MIDLAND PLANT UNITS 1 & 2
 CONSUMERS POWER COMPANY

SCHEMATIC DIAGRAM
 REACTOR CONTAINMENT BUILDING
 H & V SYSTEM

JOB No.	DRAWING No.	REV.
7220	E-440 (G) SH 30	5

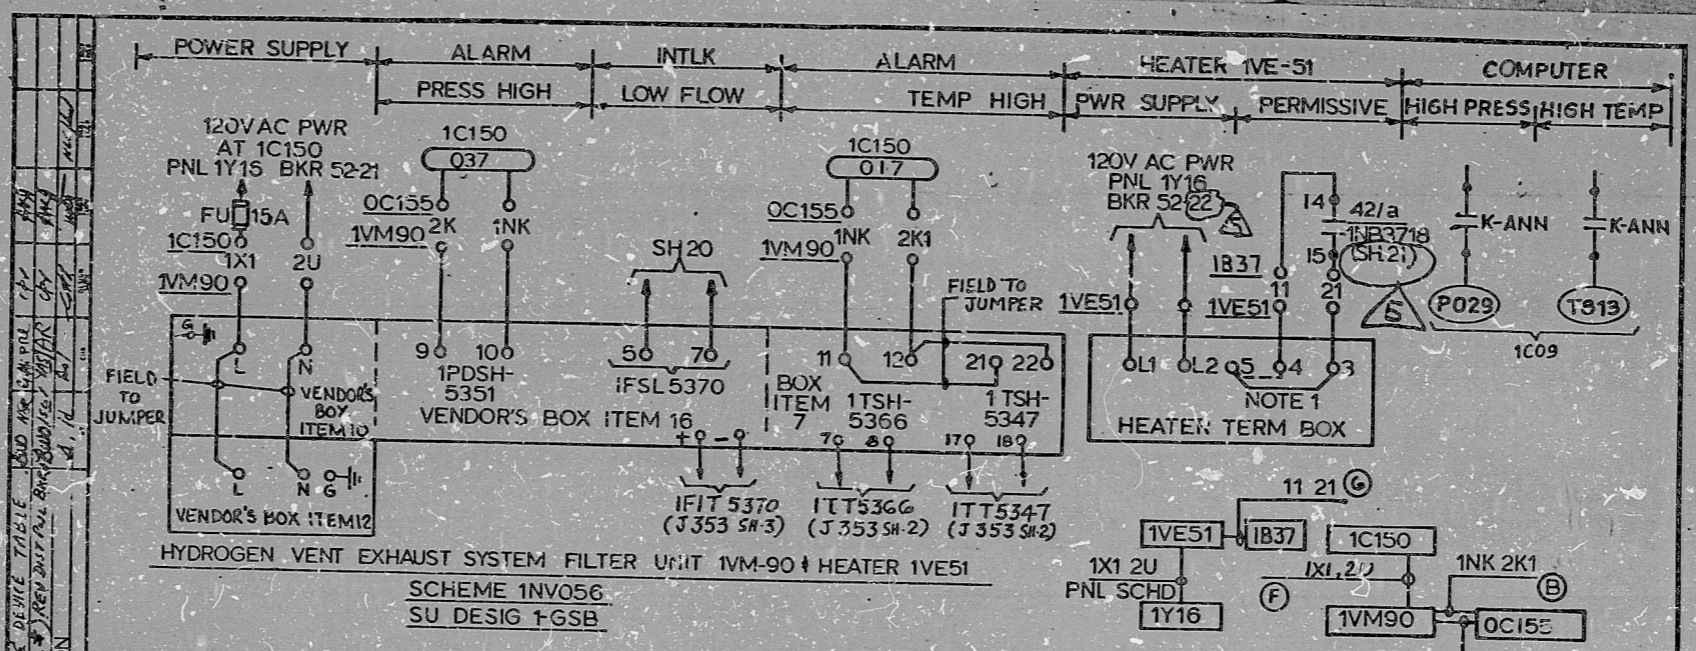
NOTE:
 1. FIELD TO REMOVE EXISTING
 JUMPER BETWEEN TERM. 5
 & 4. AND INSTALL NEW JUMPER
 BETWEEN TERM 5 & 3.
